Submitted by	Company	Date Submitted
Christine Kirsten christine.kirsten@pacificorp.com 916-207-4693	PacifiCorp	March 21, 2019

**PacifiCorp’s Comments on the Day-Ahead Market Enhancements
Phase 1: Fifteen-Minute Granularity
Third Revised Straw Proposal**

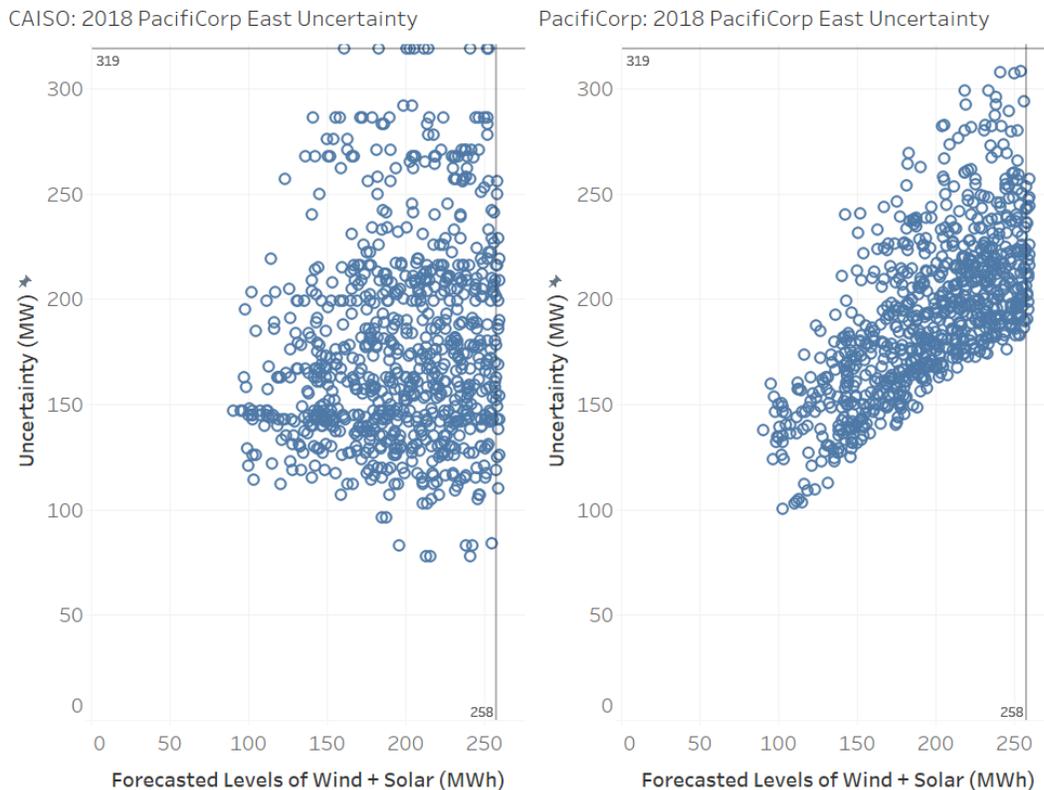
Today, PacifiCorp has a large level of wind and solar within its operating system that increases its need for intra-hour flexibility due to forecast uncertainty. PacifiCorp’s internal uncertainty calculation is dependent on the respective levels of wind, solar and load forecast for each hour and allows PacifiCorp to operate in a reliable manner. However, the CAISO’s calculation of uncertainty that is included in its flex ramp sufficiency test can vary from the requirement that PacifiCorp has calculated due solely to the fact that the CAISO does not include the forecast levels of wind and solar. The below illustration compares the relationship between forecast levels of wind and solar VERs and the current uncertainty requirement in the up direction as calculated by the CAISO and as calculated by PacifiCorp for internal needs in 2018 for the PacifiCorp East (“PACE”) balancing area during the nighttime hours.

The illustration above shows that there is no relationship between the forecast levels of VERs and the CAISO upward uncertainty requirement. This disconnect between forecasts and uncertainty requirements has the PACE system holding upward capacity above and beyond its needs at low VER forecast levels.

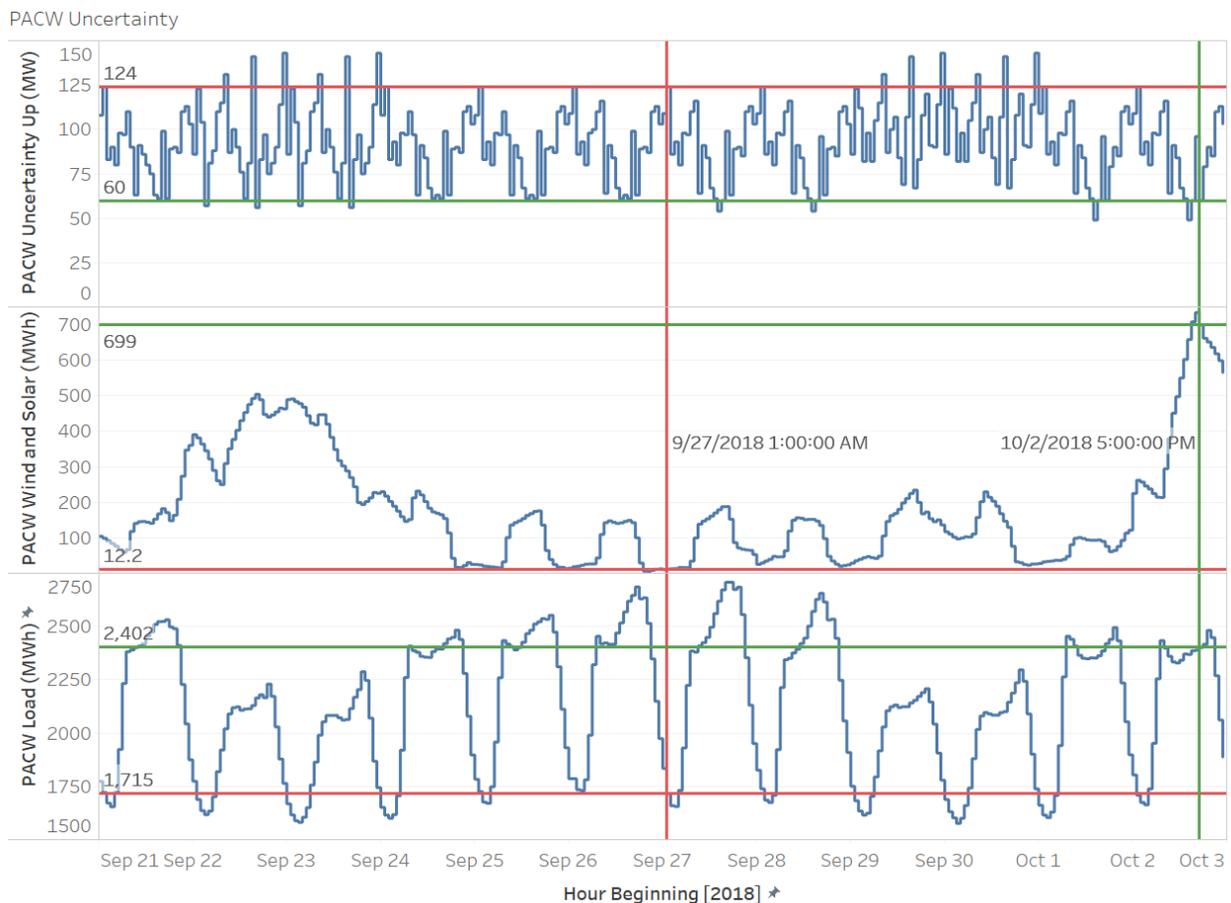
Not accounting for forecast levels of wind and solar often leads to nonsensical results. Observe the below conditions in the PacifiCorp West (“PACW”) balancing area on September 27, 2018, at 0100 Pacific Daylight Time (“PDT”). On September 27th, the VER forecast is 12 megawatt-hours (“MWh”) and the load forecast is 1,715 MWh. During this period the CAISO flexible ramp sufficiency test required PacifiCorp to hold 124 MW of upward capacity. In contrast, on October 2, 2018, at 1700 PDT the VER forecast is 699 MWh and the load forecast is 2,402 MWh while the upward capacity requirement is 60 MW. It is nearly impossible to make the argument that the upward uncertainty in the middle of the night with a negligible wind forecast is twice as great as the upward uncertainty during the evening peak where wind and solar combined is forecast to be approximately one third of load.
